Plato's Madison

Adaptive Reuse Apartment Project

3841 E Washington Avenue, Madison, WI 53714

SHEET TITLE
 CITY LANDSCAPE PLAN

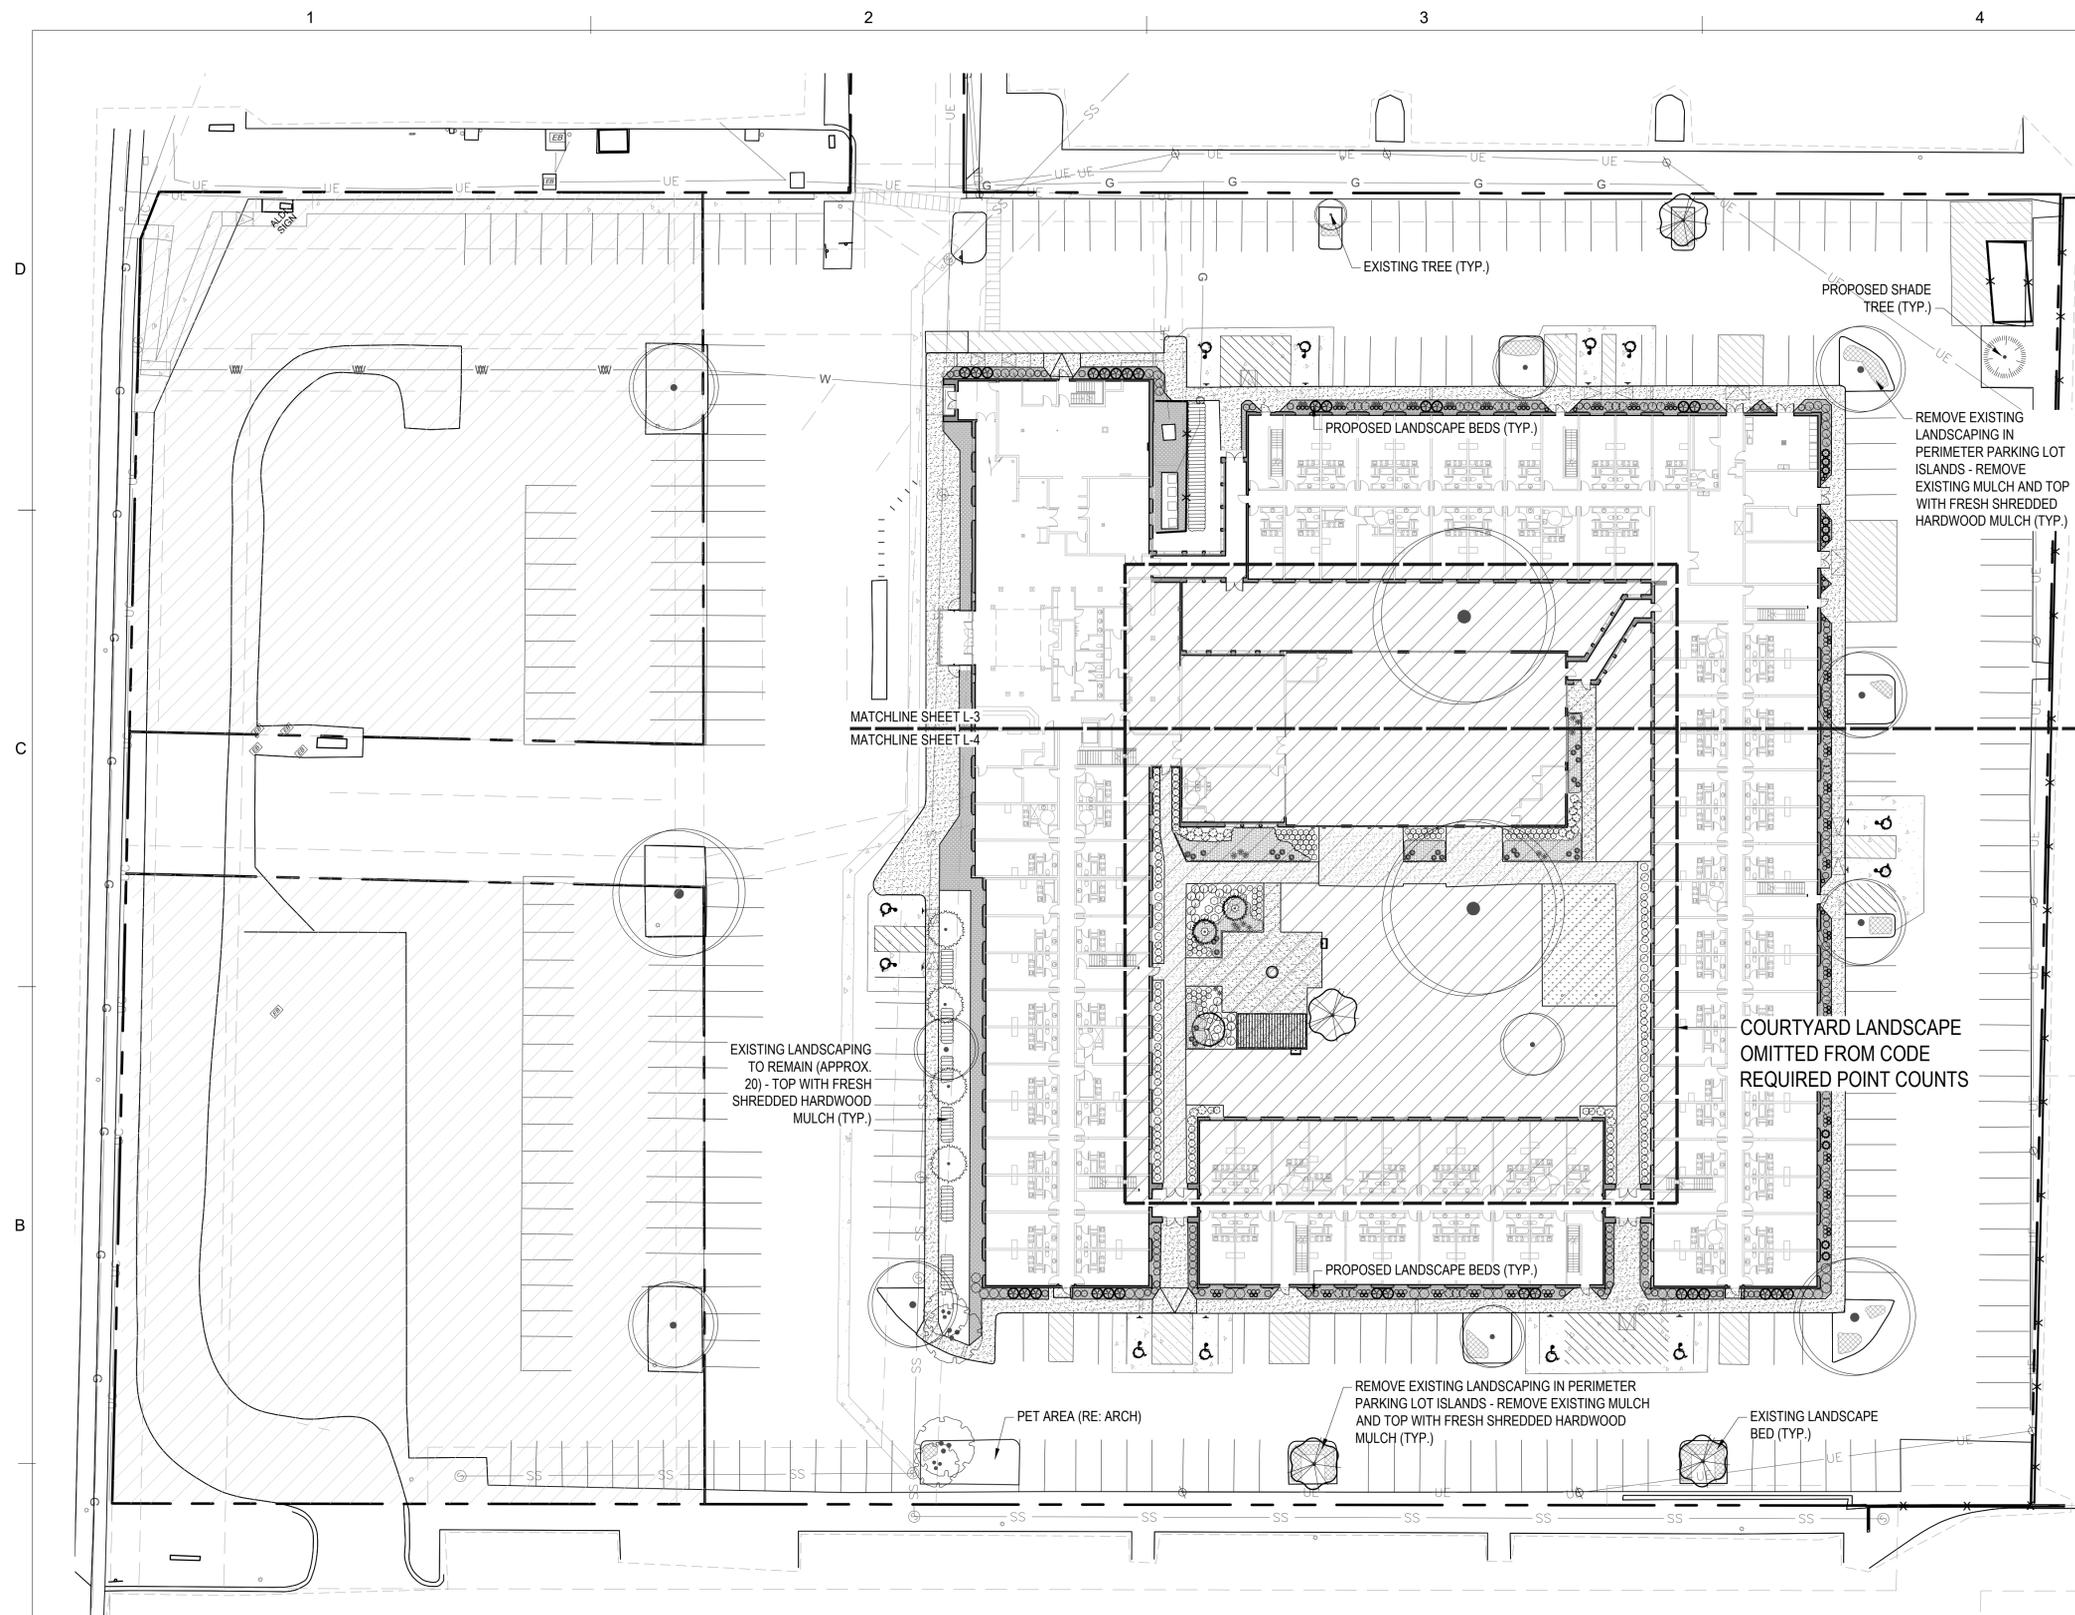
- The applicant shall provide a landscape plan as part of the Final Approval application, including plantings in the courtyard space and the use of bark mulch.

We have updated the courtyard landscaping significantly. Where there is exposed earth or mulch beds in the landscape islands around the building, we will enhance the planting in those areas and add fresh bark mulch. This also includes bark mulch in the courtyard space.

SHEET TITLE
 PHOTOMETRICS

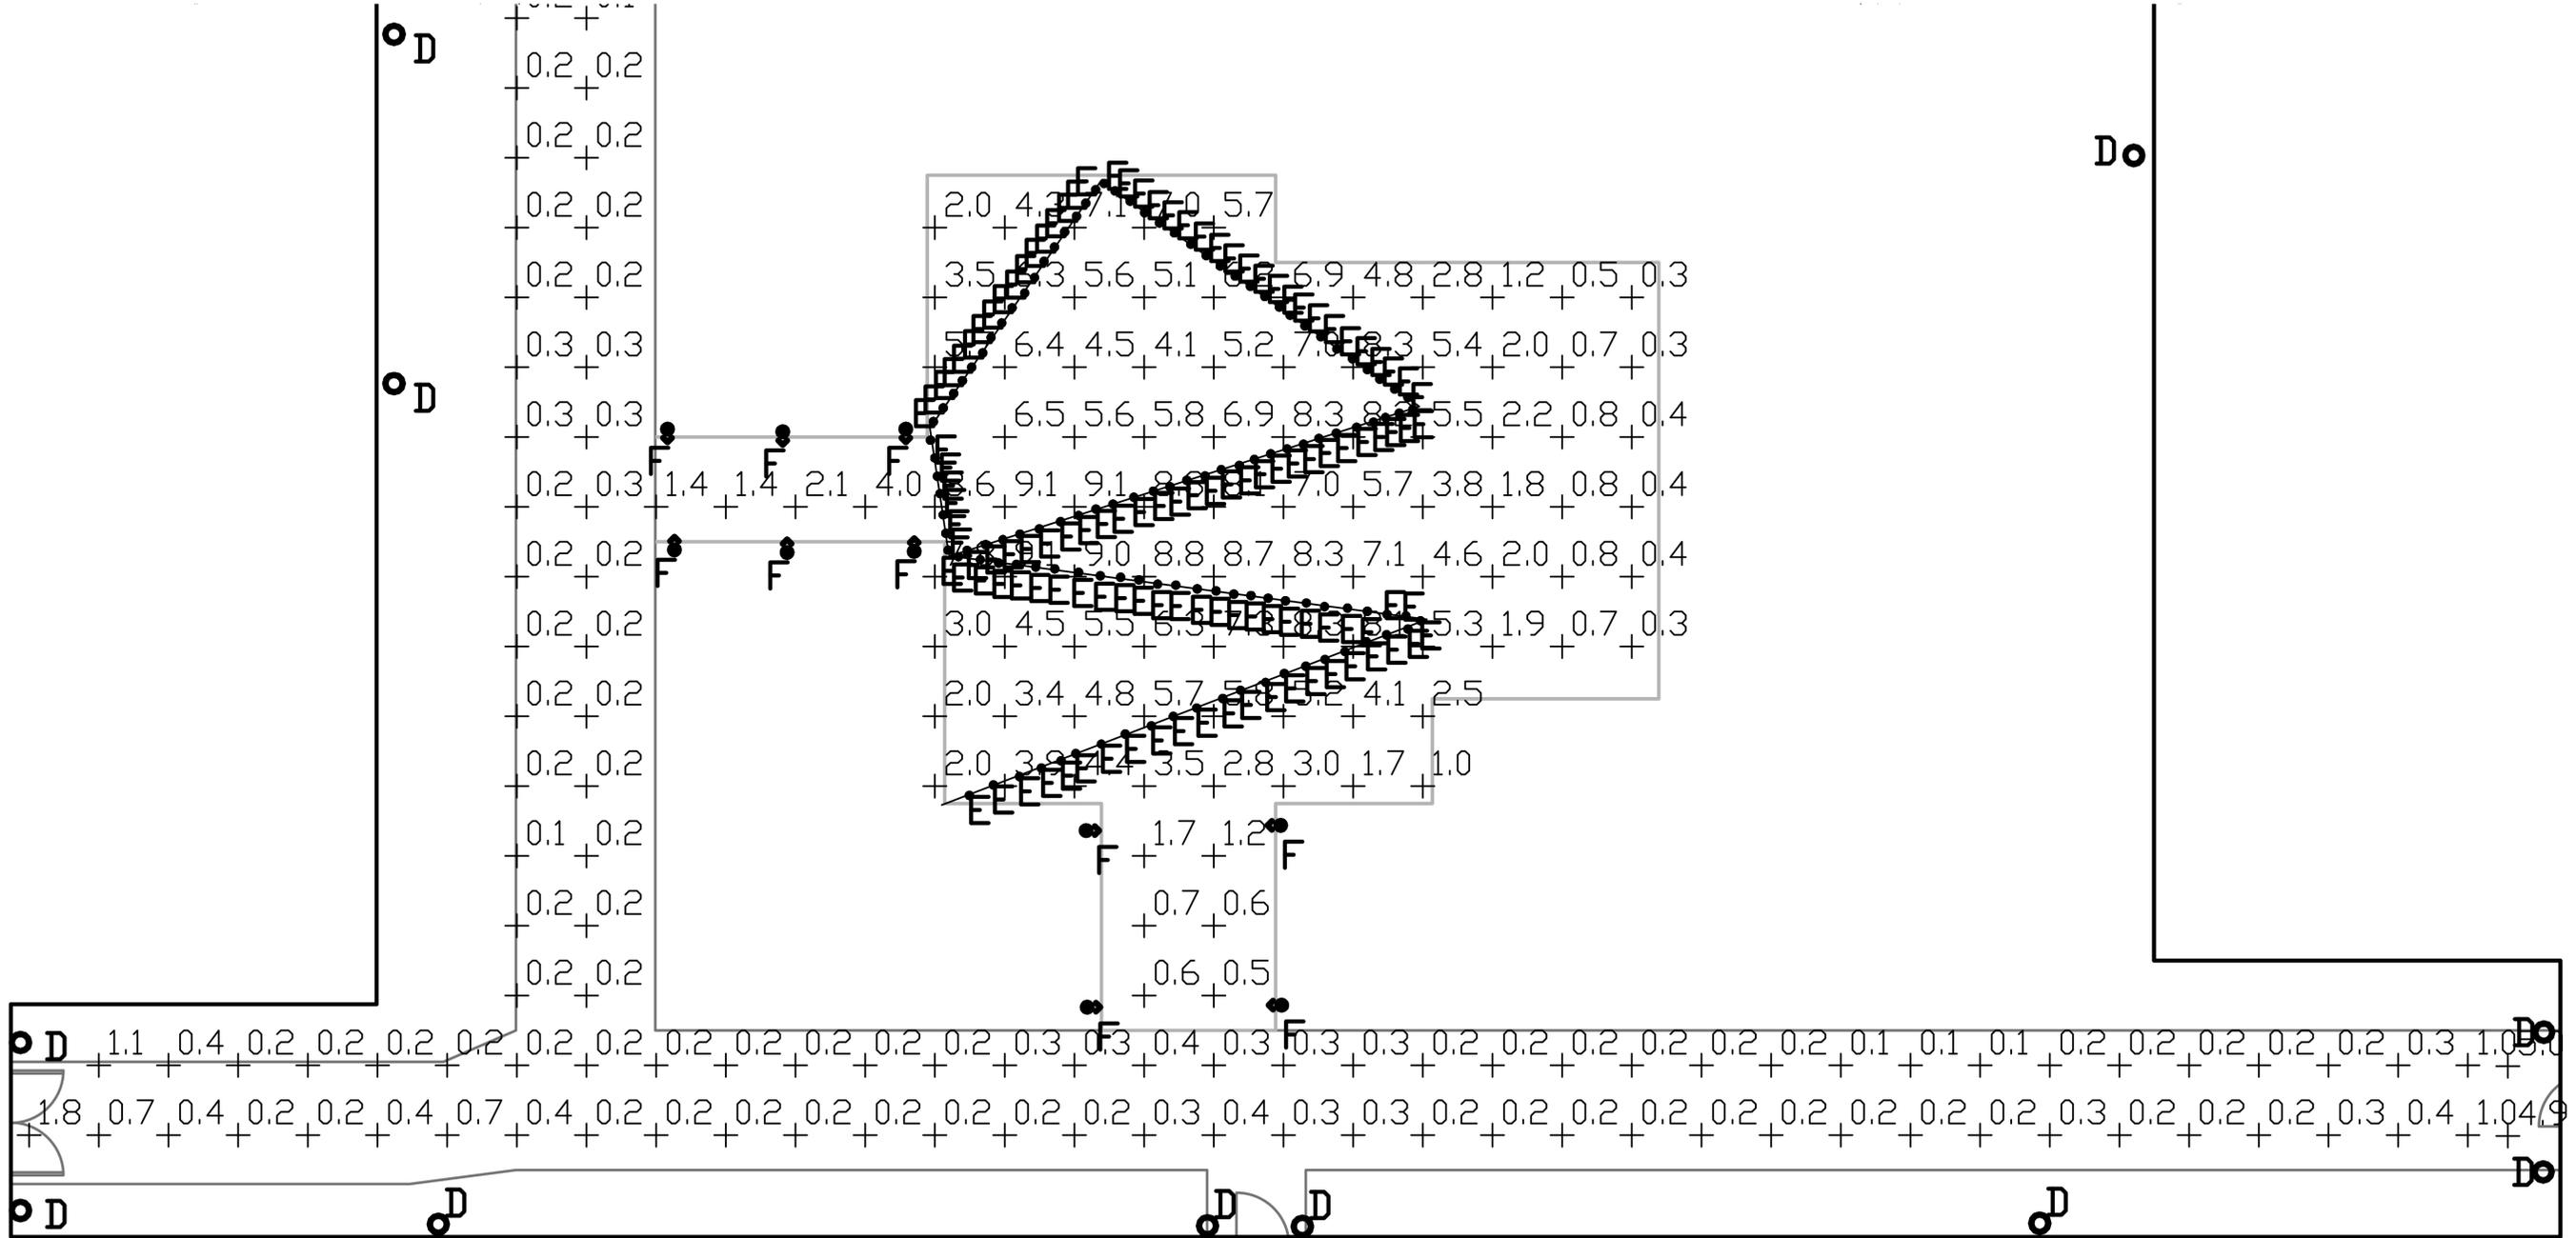
- The applicant shall update the photometric plan that responds to the concerns in the staff report, including lighting in the courtyard and along pedestrian pathways.

An updated photometric plan is attached herein.

SUBMISSION DATES UDC AND LUA
SHEET TITLE ENLARGED SITE PLAN 1
PROJECT NUMBER 2280028
SHEET NUMBER C401

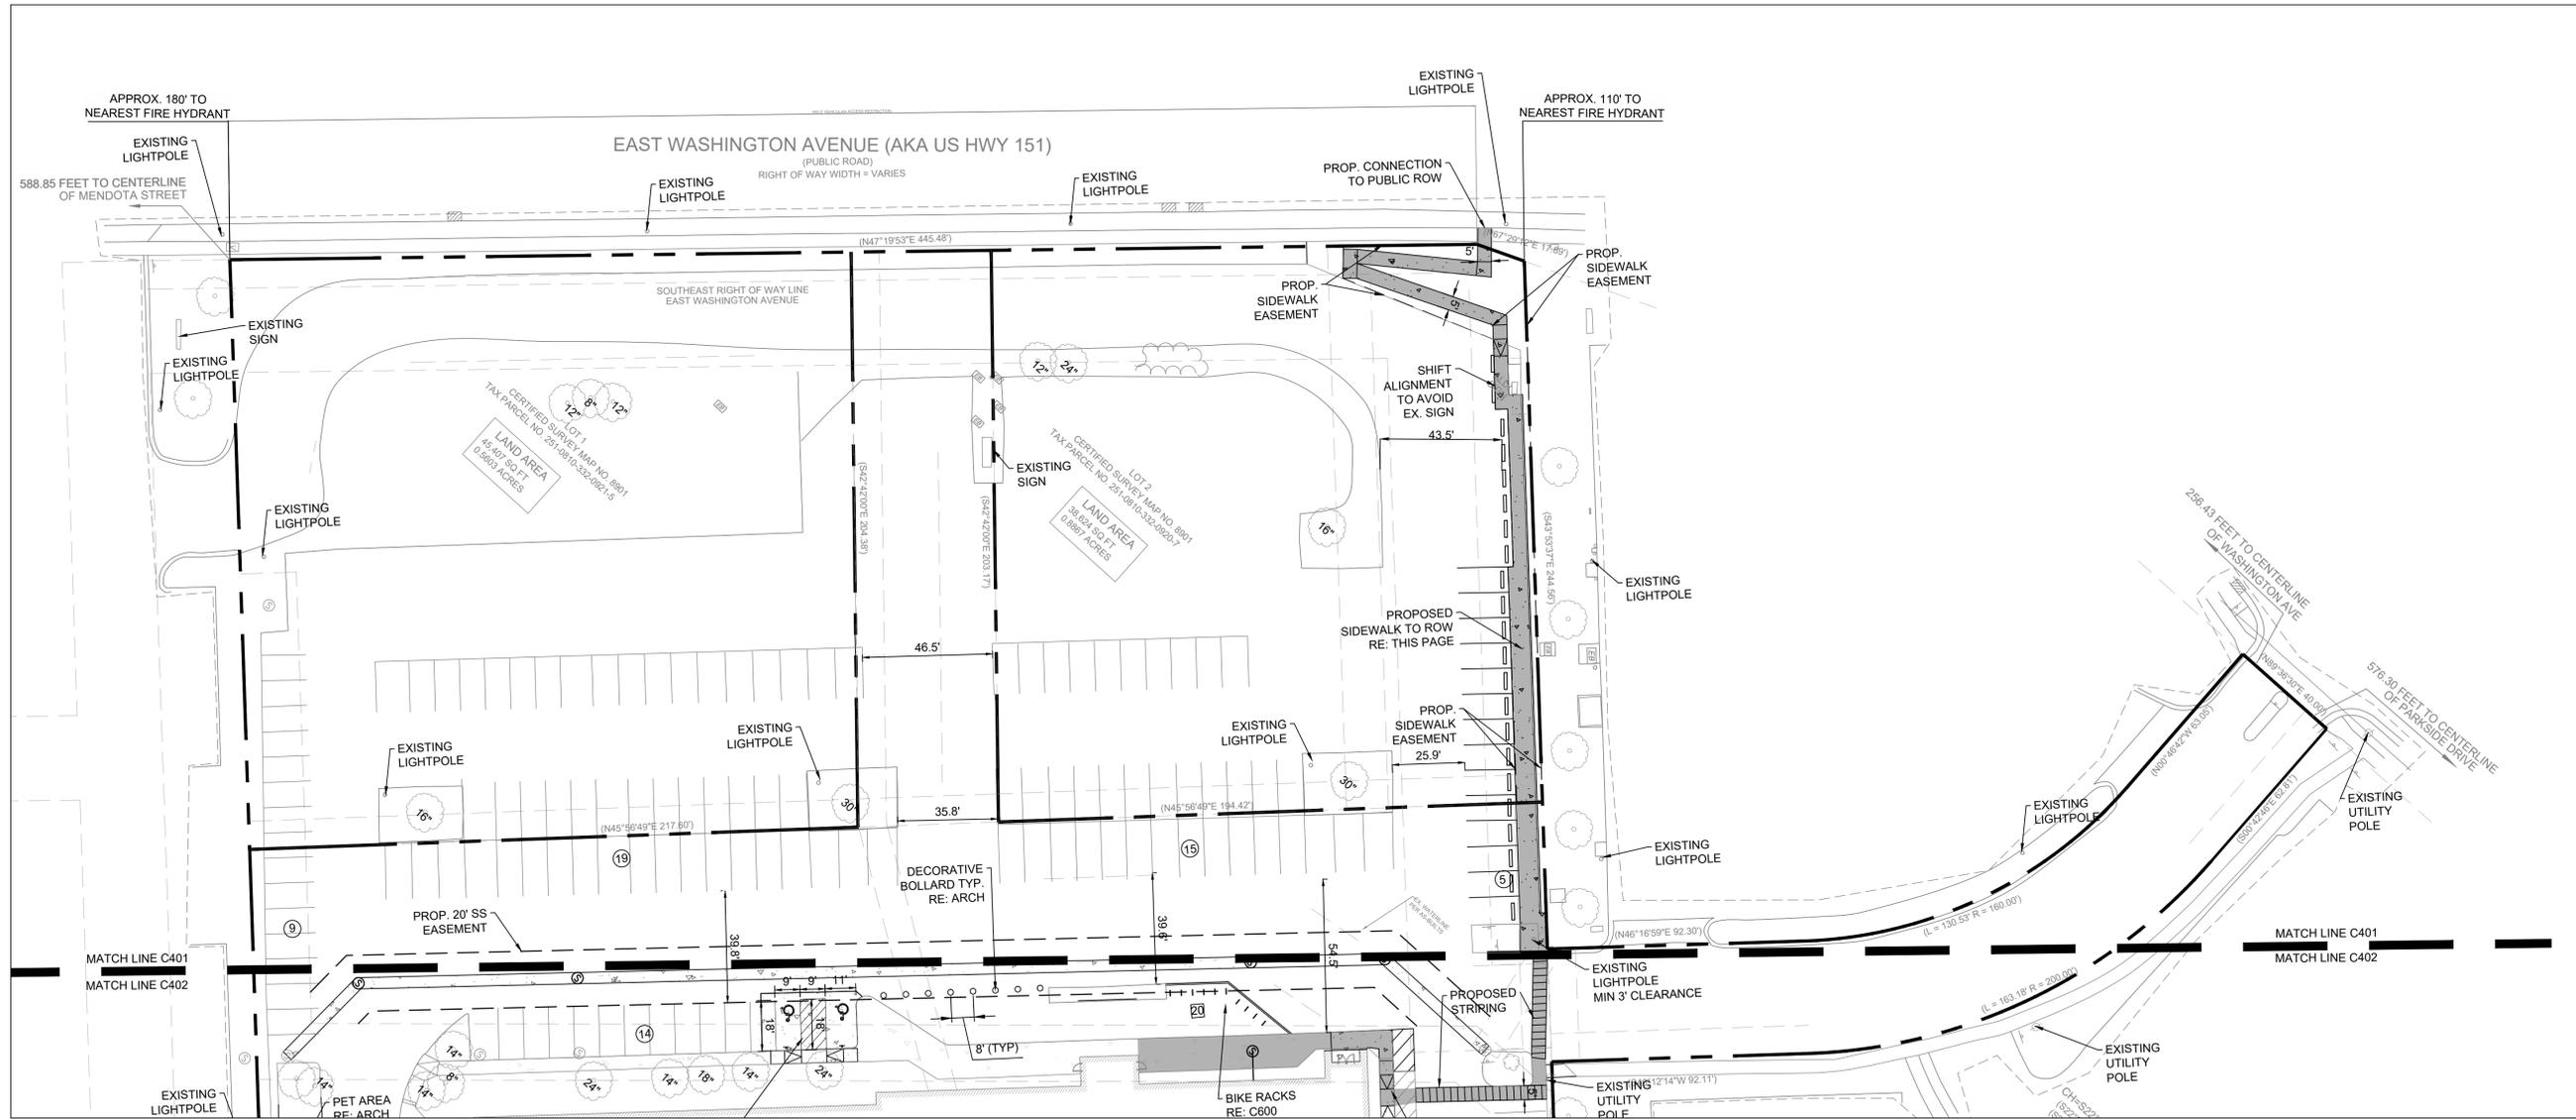
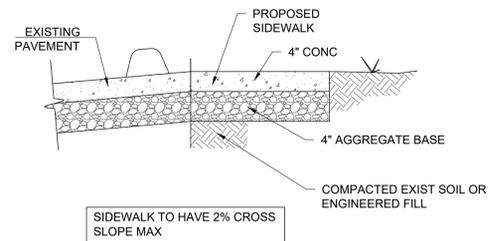
- The advisory motion reflects that conditional use standard #9 has been fulfilled; standard #5 requires additional enhancement or rework, including consideration being given to the location and treatment of the pedestrian crosswalk connection and consider a true connection that is raised and protected.

We have reworked the pedestrian connection to E. Washington to offer a permanent concrete sidewalk, protected from traffic with parking bumpers along the adjacent parking lot. We have also moved the outdoor bike parking to the front of the building – blocking off that area to cars where the port cochere drive thru was previously.
